# Gatwick Airport Northern Runway Project

Appendix 14.7.9: The Noise Envelope – Tracked Version

VERSION: 3.0

DATE: JUNE 2024

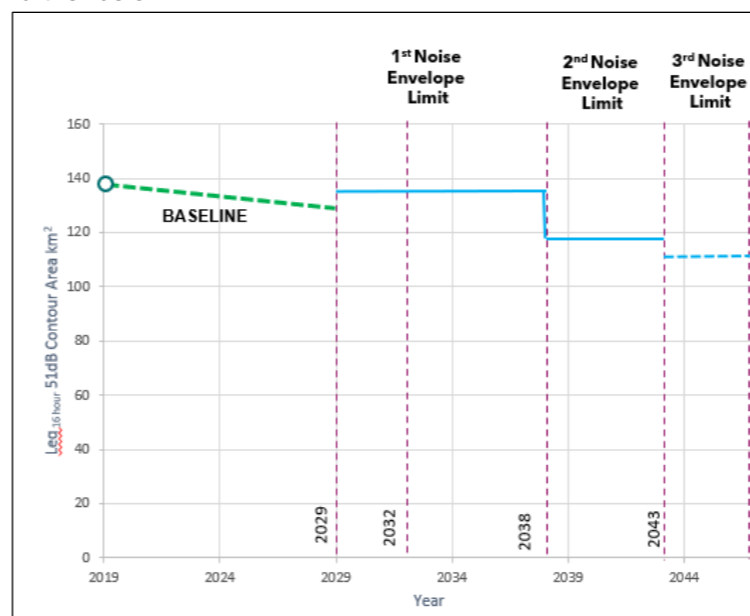
- Leq 16 hour day 51 dB [135.5 km<sup>2</sup>](#) ~~146.7~~
- Leq 8 hour night 45 dB [146.9 km<sup>2</sup>](#) ~~157.4~~

- Leq 16 hour day 51 dB [119.4 km<sup>2</sup>](#) ~~125.7~~
- Leq 8 hour night 45 dB [134.6 km<sup>2</sup>](#) ~~136.4~~
